**GWF ENERGY, LLC**

<b>DOCKET</b>	
<b>08-AFC-7</b>	
DATE	JUL 23 2009
RECD	JUL 23 2009

Subject: Preliminary Staff Assessment Workshop Response to Public Comments and Tracy Hill's Filing  
GWF Tracy Combined Cycle Power Plant Project (08-AFC-7)

**FIGURE PSA WORKSHOP  
RESIDENTIAL VIEW POINTS**  
GWF TRACY COMBINED CYCLE  
POWER PLANT PROJECT  
SAN JOAQUIN COUNTY, CA

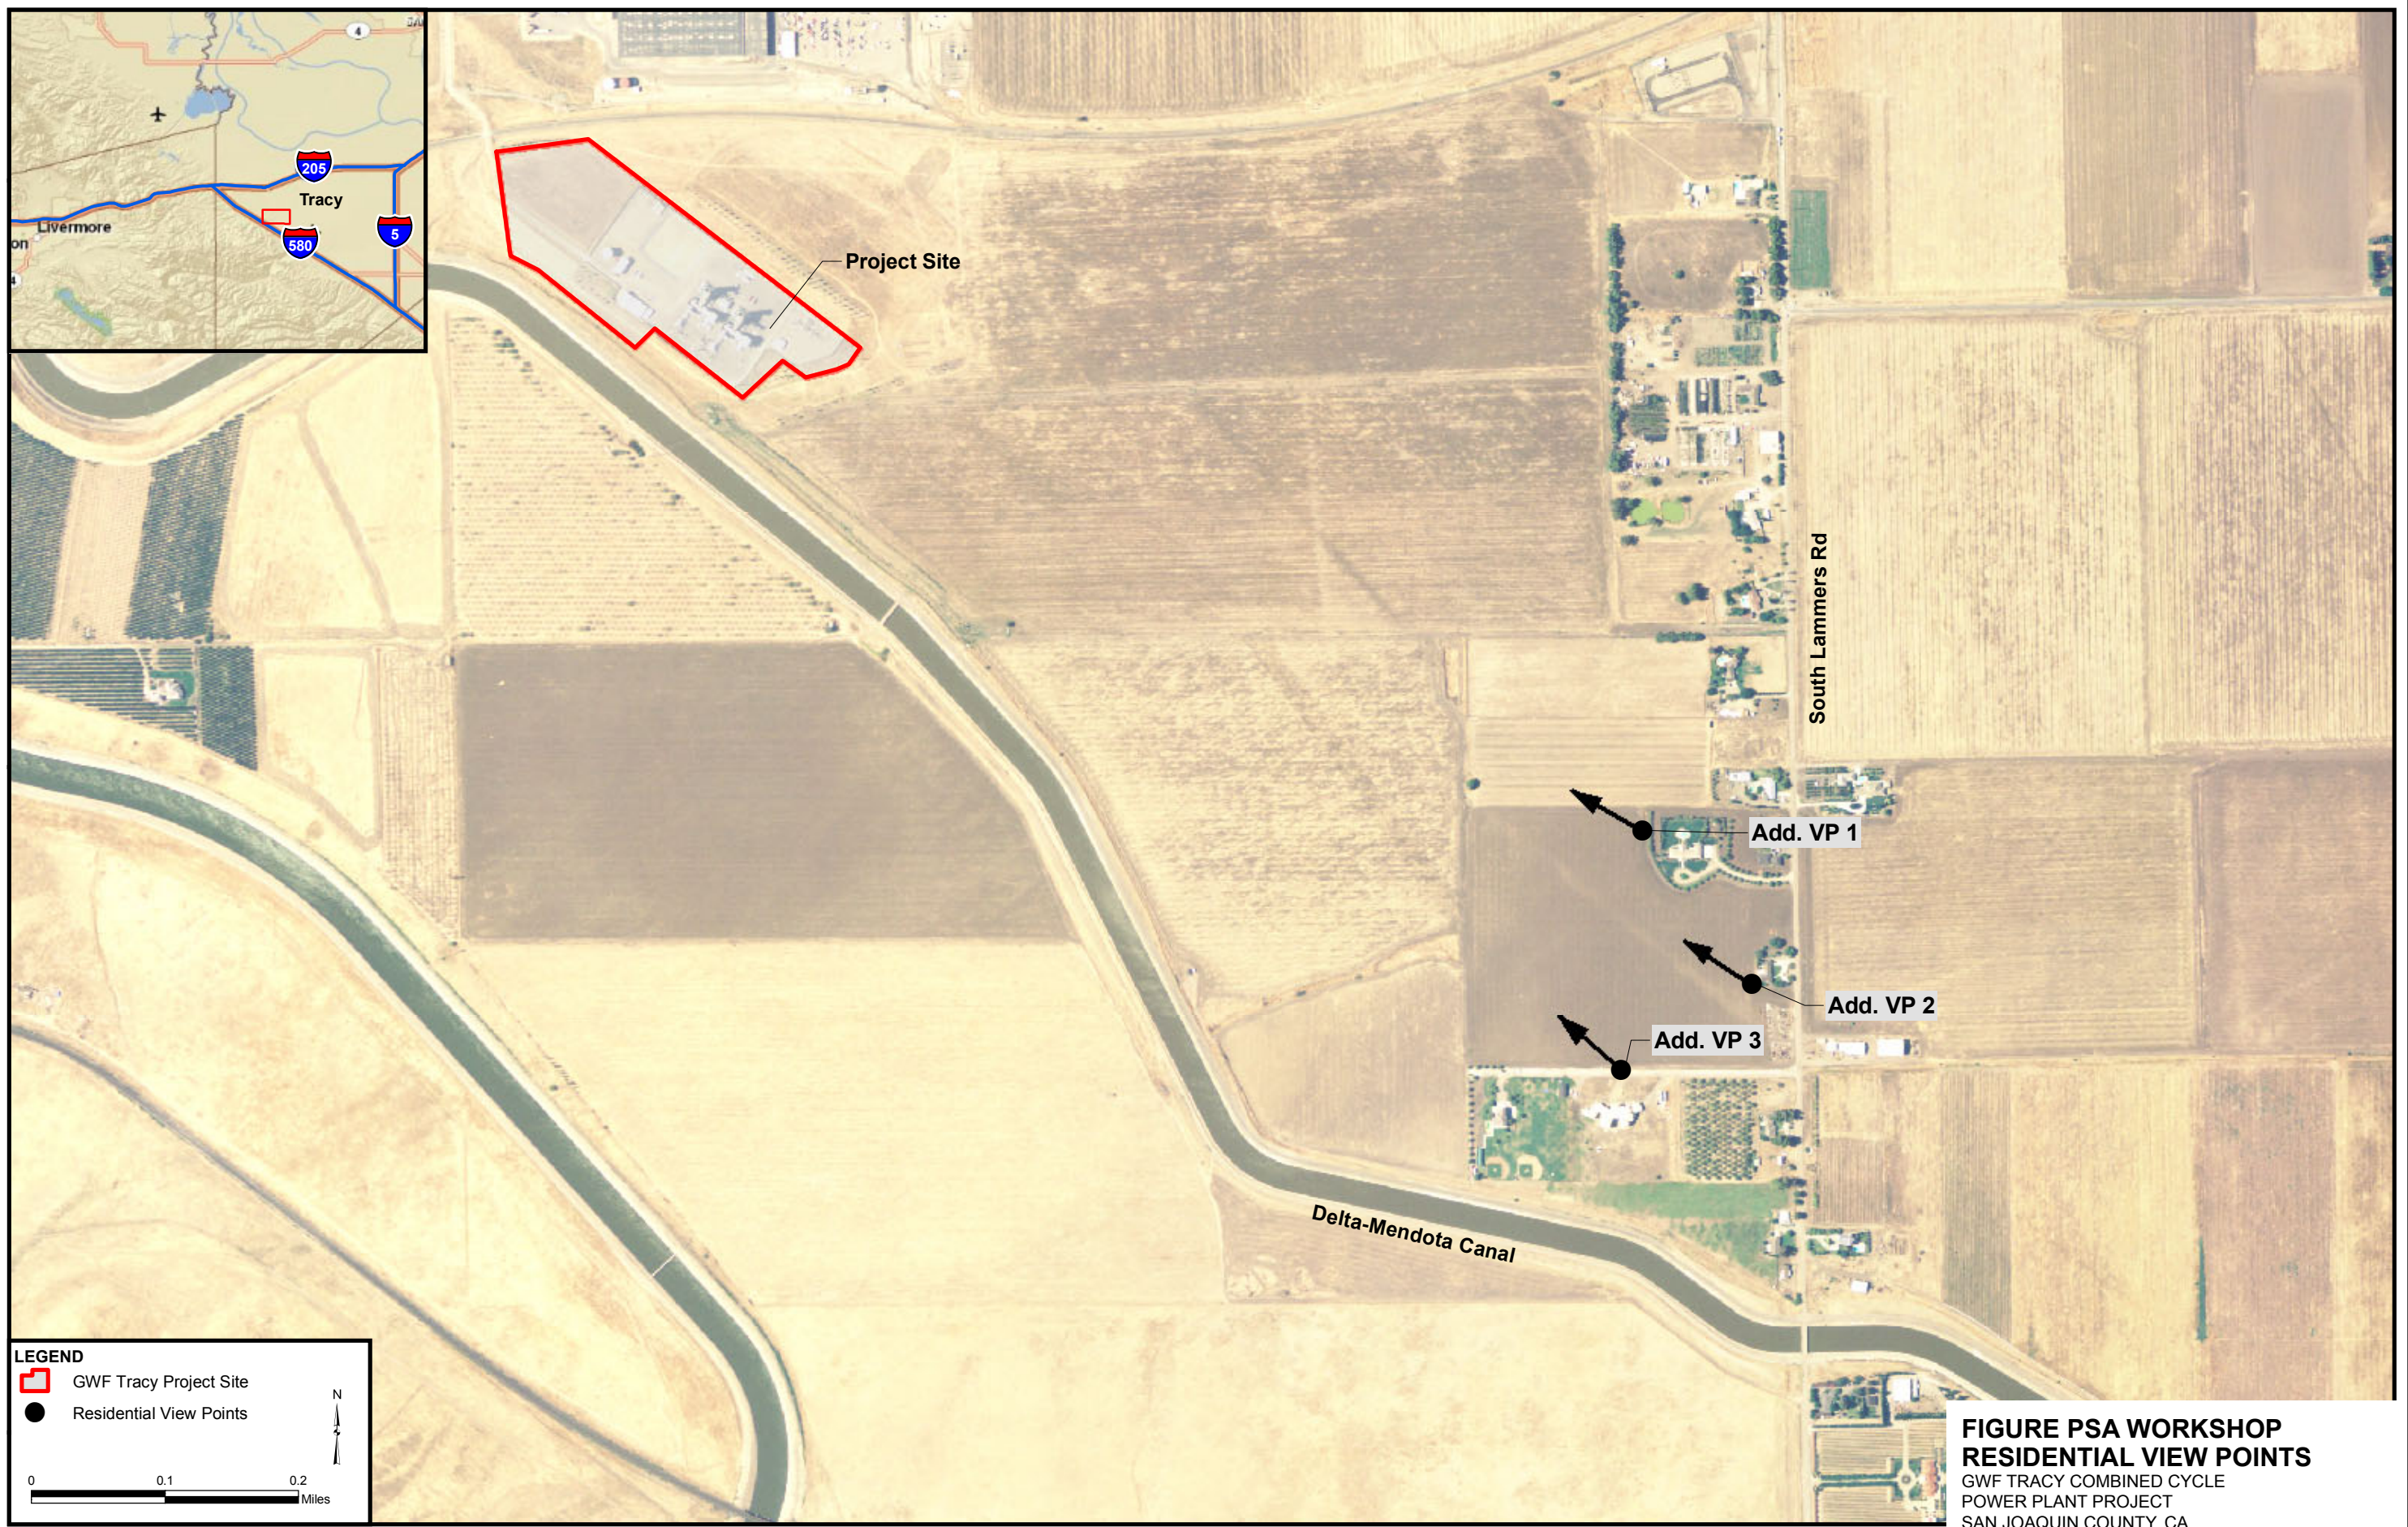
During the June 23, 2009 GWF Tracy Combined Cycle Power Plant Project Preliminary Staff Assessment (PSA) workshop, a member of the public voiced concerns with the projects visual and noise impacts on their homes. In addition, Tracy Hills, LLC, docketed a similar visual resources concern on July 3, 2009 (Docket Log # 52303) regarding cumulative visual impacts on the approved single-family residential development. In response to these comments, GWF Energy LLC, has prepared three additional view points from the homes in question. Figure PSA Workshop Residential View Points shows the location of these additional view points, the closest being approximately  $\frac{3}{4}$  of a mile from GWF Tracy. Figures PSA Workshop View Point 1a through 1c show the existing view, simulated view of the project after construction, and a simulated view at 20 years after planned landscaping has matured from View Point 1 (from Figure PSA Workshop Residential View Points). Likewise, Figures PSA Workshop View Point 2a through 2c and PSA Workshop View Point 3a through 3c show the same representations from view points 2 and 3. As shown from these figures, the expected visual impacts at these homes are not expected to be significant.

**FIGURE PSA WORKSHOP  
 EXPECTED NOISE LEVELS**  
 GWF TRACY COMBINED CYCLE  
 POWER PLANT PROJECT  
 SAN JOAQUIN COUNTY, CA

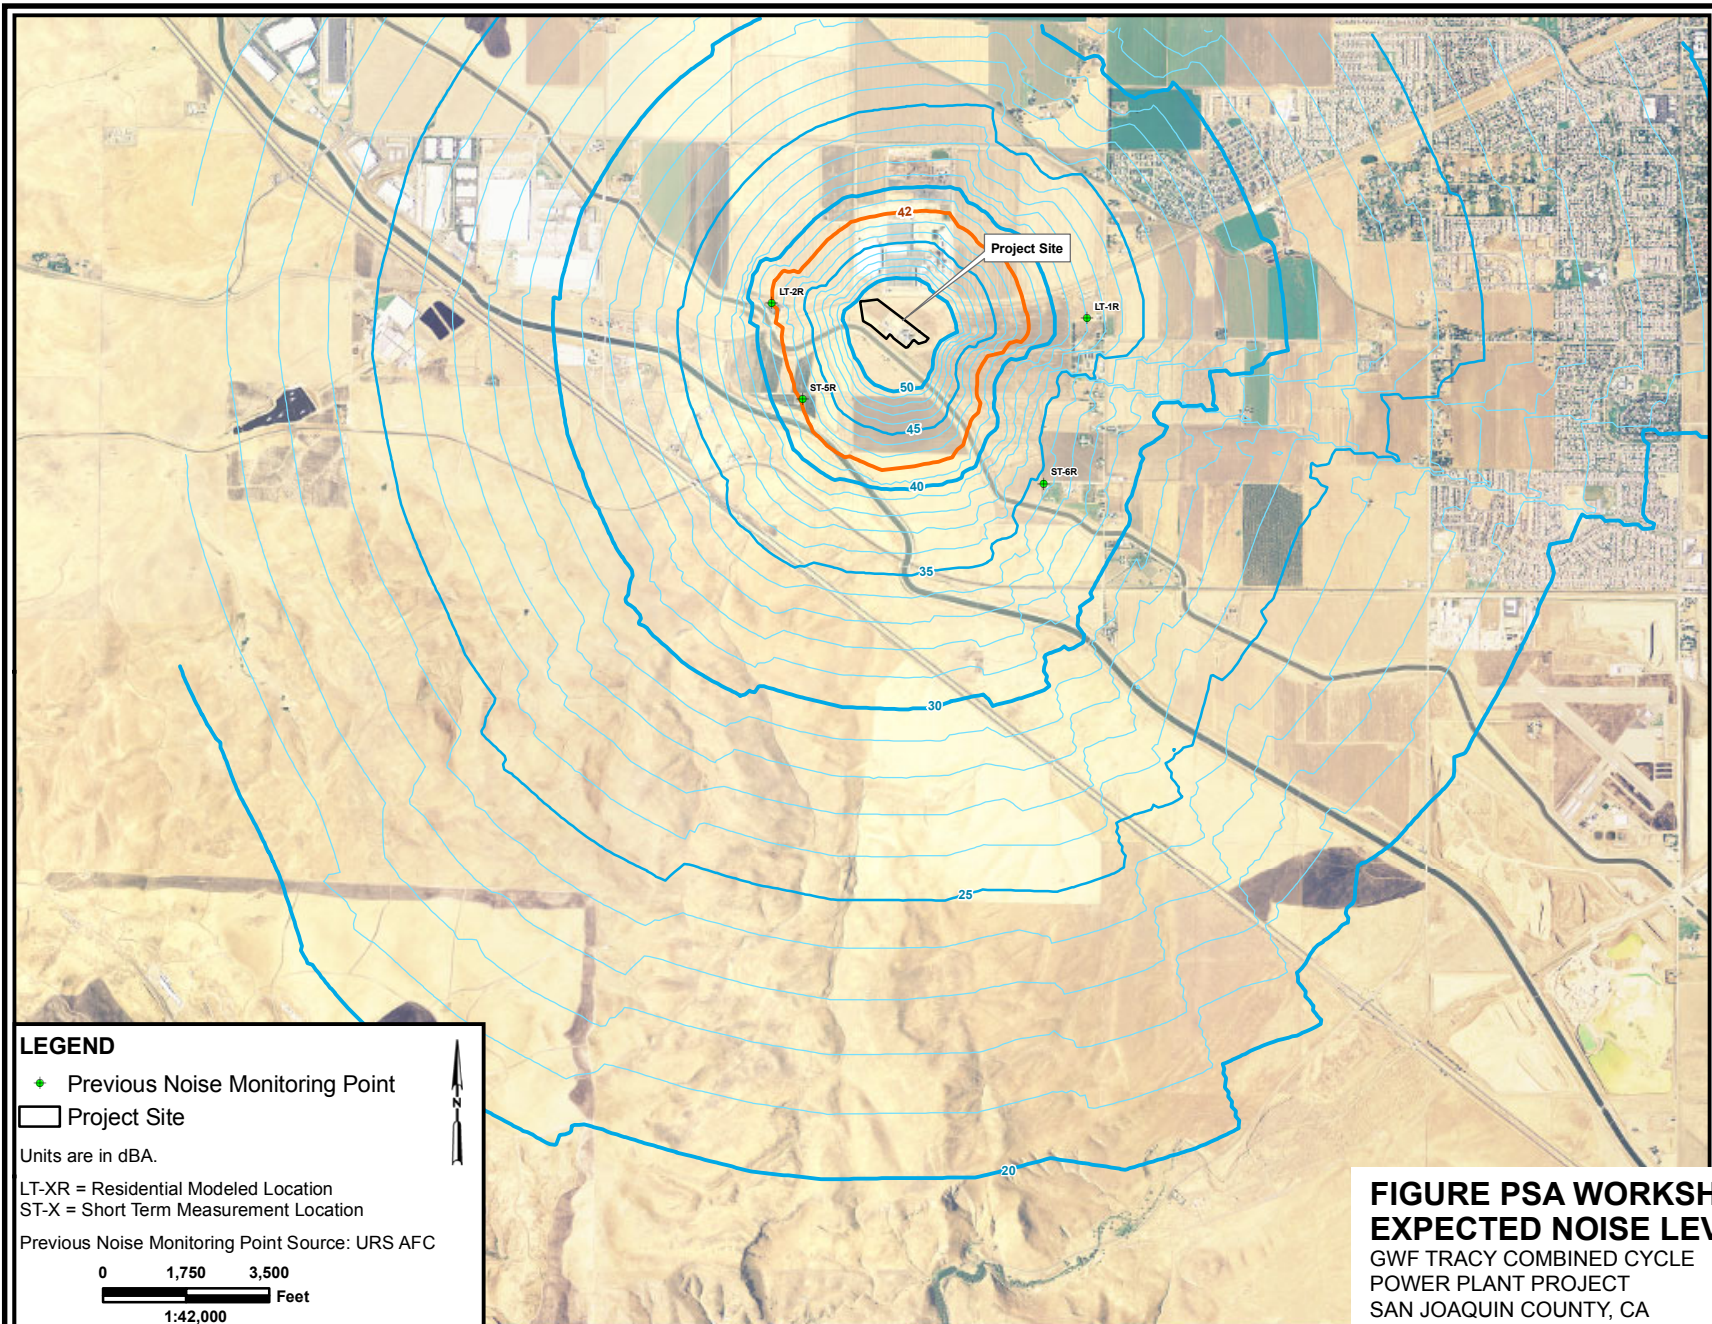
To respond to the noise impact concerns raised, GWF Energy LLC prepared Figure PSA Workshop Expected Noise Levels. This figure shows that expected noise levels for the project area. The noise levels at the homes concerning the public during the PSA workshop is expected to be below 34 decibels (dbA).
